January 26, 2022

**SUBJECT: Constantine Hydroelectric Project (FERC No. 10661)
Response to Final License Application Additional Information
Requests**

Attachment B – Revised Shoreline Stability Assessment Study Report

Attachment D – Revised Exhibit G Drawings

Figure 1. Shoreline Erosion Potential and Assessment Site Locations June & September 2019

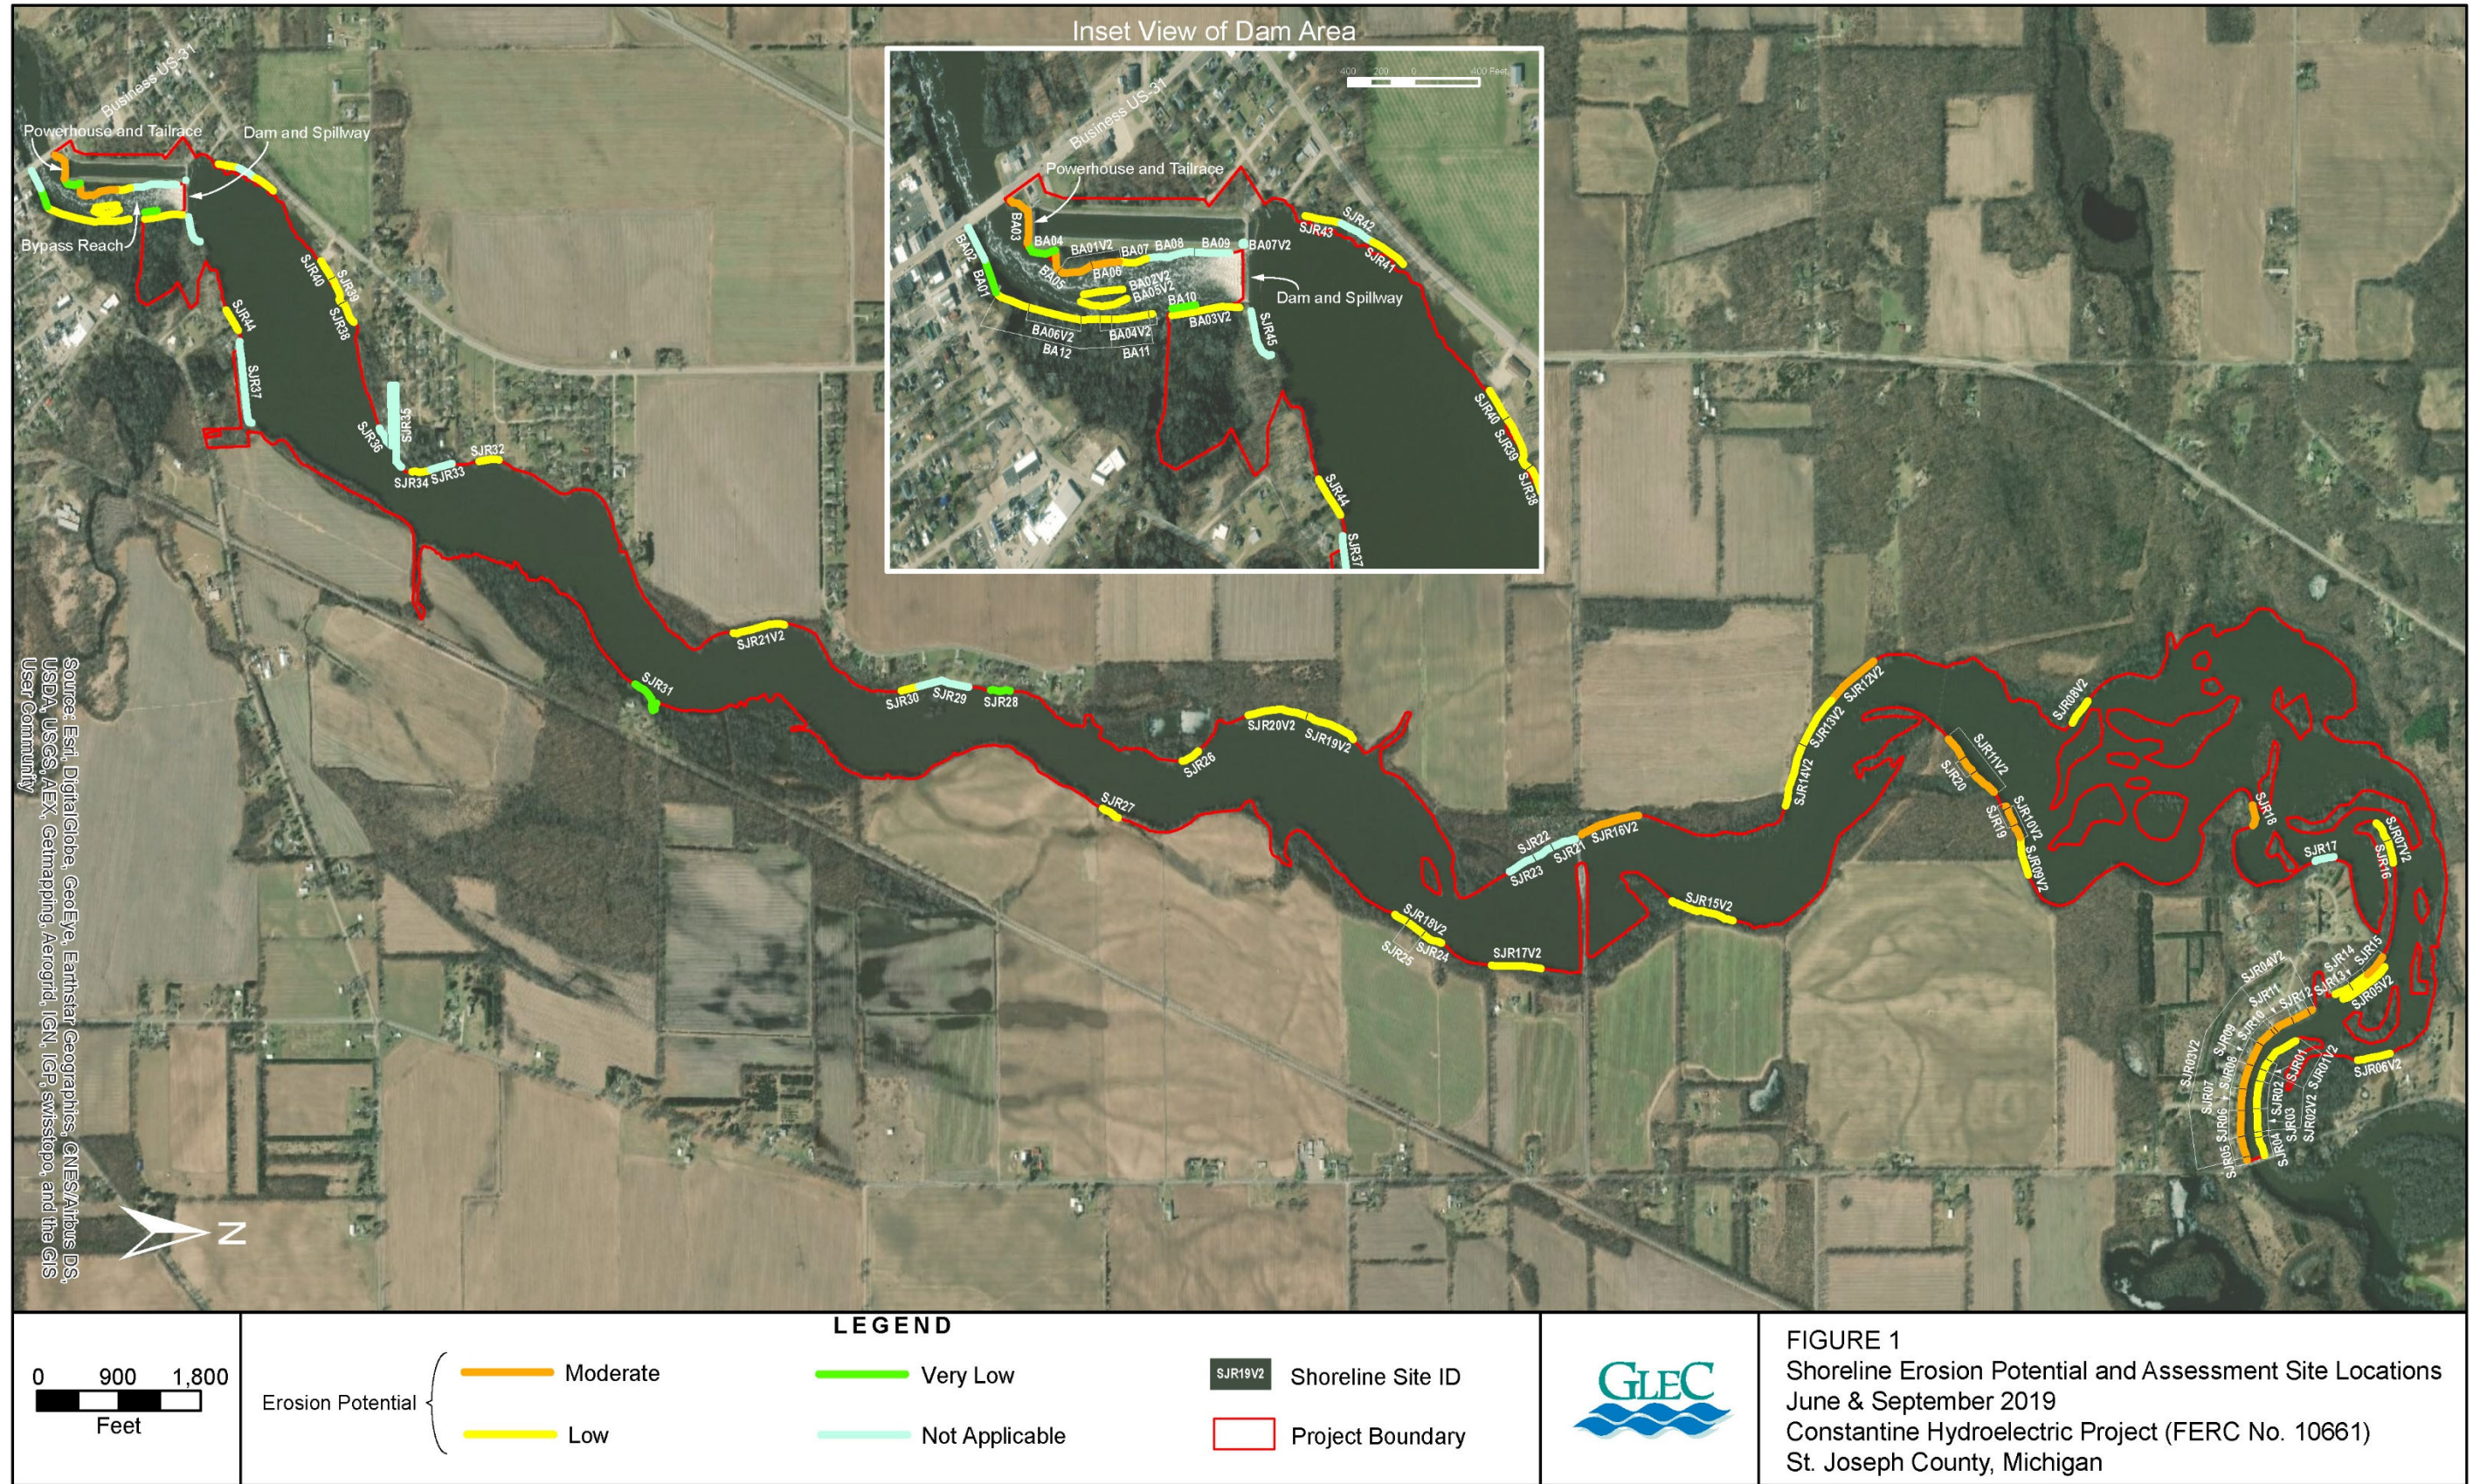
Section E.3.2, *Soils and Sediment*, page E-15, states that a shoreline stability assessment was conducted of the project's reservoir, bypassed reach, and tailrace area to identify sites of erosion or shoreline instability. The results of the assessment is described in the Shoreline Stability Assessment Report, which is included as appendix C of the application. The results of the assessed locations are presented in table 2 and table 3 of the Shoreline Stability Assessment Report. However, there is no figure showing the location of assessed locations, whose absence is described in section 2.3 of the Summary of Initial Study Report Meeting filed on May 8, 2020. Therefore, please provide a figure showing the location of assessed locations.

FERC Comment:

I&M's subconsultant that conducted the Shoreline Stability Assessment developed a figure showing the locations of the sites assessed during the study. The figure is included in Attachment B (Figure 1) of this filing.

BA16 was misidentified in the FLA as a location along the existing portage trail. This location is actually located near the spillway along the power canal embankment. During the development of the figure to address FERC's previous comment, it became apparent to I&M's subconsultant who completed the study that there were some corrections needed in the report. Therefore I&M's subconsultant has revised the report which is included in Attachment B of this filing. The site that

was formerly referred to as BA16 is now referred to as BA07V2 in the revised report. I&M will assess any erosion issues that exist along the existing portage trail during the design phase of recreation improvements and implement appropriate control measures to address any future issues. Details of the issue and remediation will be included in the Recreation Management Plan developed by I&M.

EXHIBIT G-1 SHEET 1 OF 2

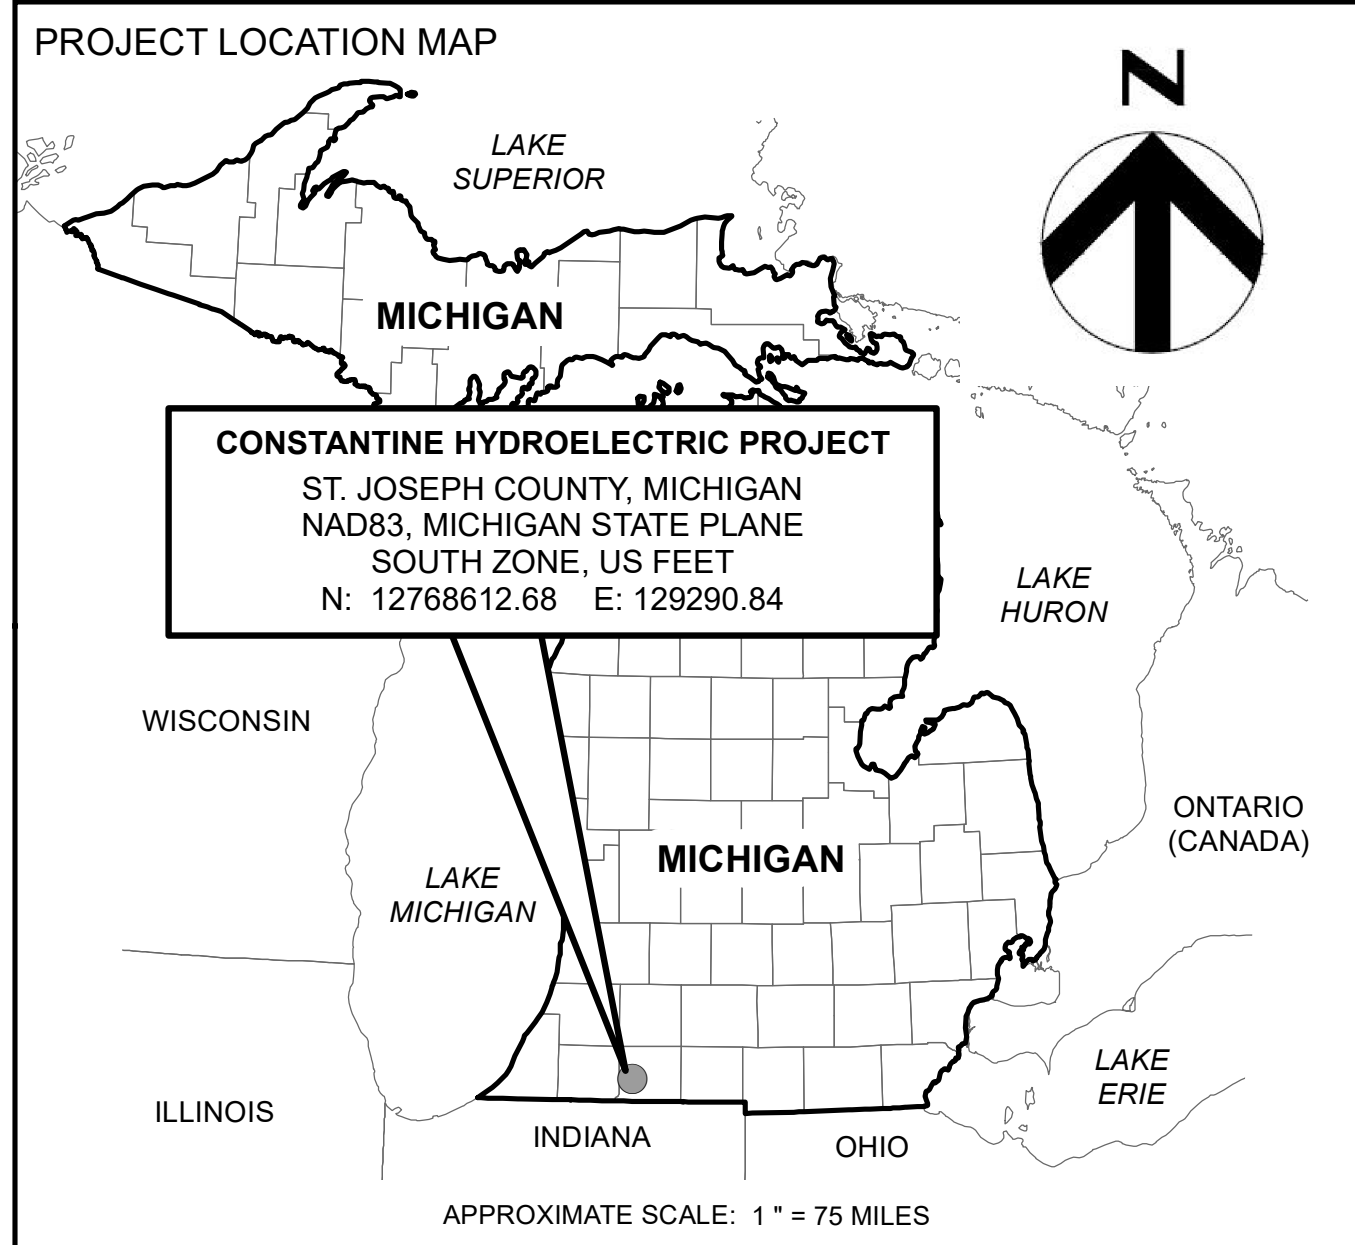
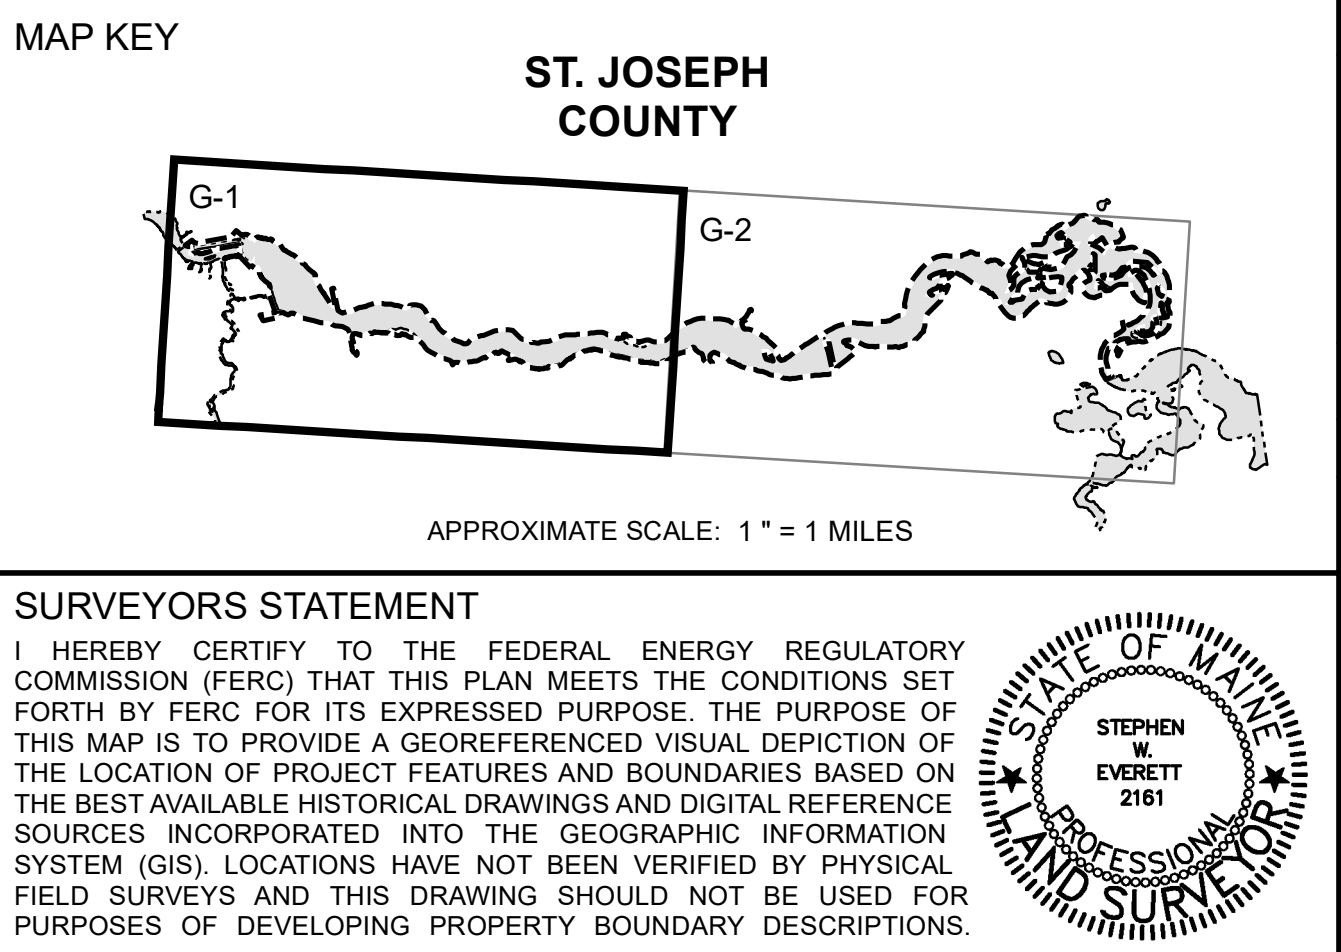
Section 5.18(a)(5)(i) of the Commission's regulations, which references section 4.61 [see section 4.41(h)] requires, in part, that an application show the relative locations and physical interrelationships of the principal project works and other features described under paragraph (b) of this section (Exhibit A) that complies with section 4.41(h)(1). The project's interconnection with Indiana Michigan Power's electrical grid and portage route are not identified on Exhibit G. Therefore, please revise the Exhibit G drawings to clearly identify and label the project's interconnection with Indiana Michigan Power's electrical grid and portage route.

Section 5.18(a)(5)(i) of the Commission's regulations, which references section 4.61 [see section 4.41(h)] requires, in part, that an application includes an Exhibit G with a map or series of maps that complies with section 4.41(h)(4) and identify by legal subdivision non-federal lands within the project boundary. The boundaries and ownership of non-federal lands that are located within the project boundary are not indicated on Exhibit G. Therefore, please revise the Exhibit G drawings to identify by legal subdivision non-federal lands within the project boundary.

Exhibit G shows the project boundary crossing a corner of the Constantine Project tailwater fishing access parking area, excluding most of the parking area from the project boundary. Please clarify if the tailwater fishing access parking area is within or outside of the project boundary and modify Exhibit G accordingly.

I&M has revised the Exhibit G drawings to label the interconnection with Indiana Michigan Power's electrical grid and portage route. The revised drawings are included in Attachment D of this filing.

All lands within the Project Boundary are owned by I&M and a note has been added to the Exhibit G drawings. The following note has been added to the drawings: “The Licensee either owns in simple fee or possesses flowage easements over all lands within the Project Boundary required to operate the facility.”

I&M has revised the Exhibit G drawing to include the tailwater fishing access parking area.

The parcel shown at Featherstone Road contains the detached dike and the access point to the detached dike for monitoring, maintenance and inspection. I&M has revised the Exhibit G drawing to denote access to the dike.
